HLR JEFF HAMILTON SUBDIVISION

APPLICATION NUMBER 4 DATE April 17, 2014

REQUEST Subdivision

DETAIL SITE PLAN

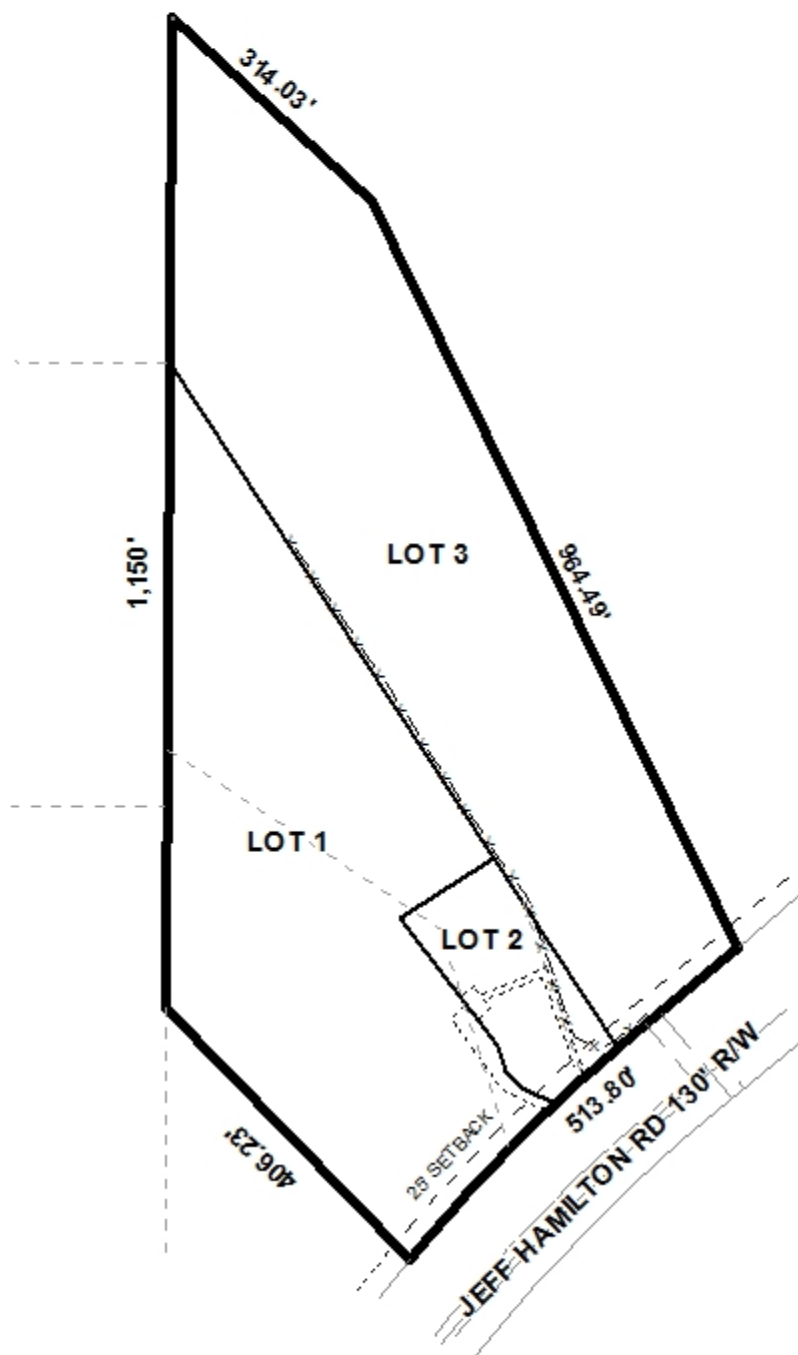
There appears to be a discrepancy in relation to the length of the southeastern lot line/frontage distance for the proposed Lot 3 along Jeff Hamilton Road. The preliminary plat depicts 144.06'; however, Staff measures a distance of 180' ±. If approved, the Final Plat should be revised to illustrate the correct distance of the southeastern property line along Jeff Hamilton Road.

Currently, the site appears to have one existing, shared curb-cut along the lot lines of the proposed Lots 1 and 2. As a means of access management, all proposed lots should be limited to one curb-cut each, with the size, design and location to be approved by Mobile County Engineering and conform to AASHTO standards. Coordination with Mobile County Engineering is required if the applicant proposes to continue a shared curb-cut between the proposed Lots 1 and 2.

It should be pointed out that the site contains two easements; however, the applicant has not specified what type of easements are existing. If approved, a note should be placed on the Final Plat stating that no permanent structures can be constructed in any easement.

It should be pointed out that there is a small note on the preliminary plat in regards to the Notary Public that reads, *State of Mobile*. If approved, this note should be revised on the Final Plat to read *State of 'Alabama'*.

- 1) Revision of the Final Plat to illustrate the correct distance of the southeastern property line along Jeff Hamilton Road for the proposed Lot 3;
- 2) Revision of the note regarding the Notary Public on the Final Plat to read 'State of *Alabama*';

- 3) Retention of the lot size information and 25' minimum building setback line on the Final Plat;
- 4) Placement of a note on the Final Plat stating that no permanent structures can be constructed in any easement;

- 5) Placement of a note on the Final Plat stating that all proposed lots are limited to one curb-cut each to Jeff Hamilton Road, with the size, design, and location to be approved by Mobile County Engineering and conform to AASHTO standards. Coordination with Mobile County Engineering is also required if the applicant proposes a continued shared access between the proposed Lots 1 and 2;
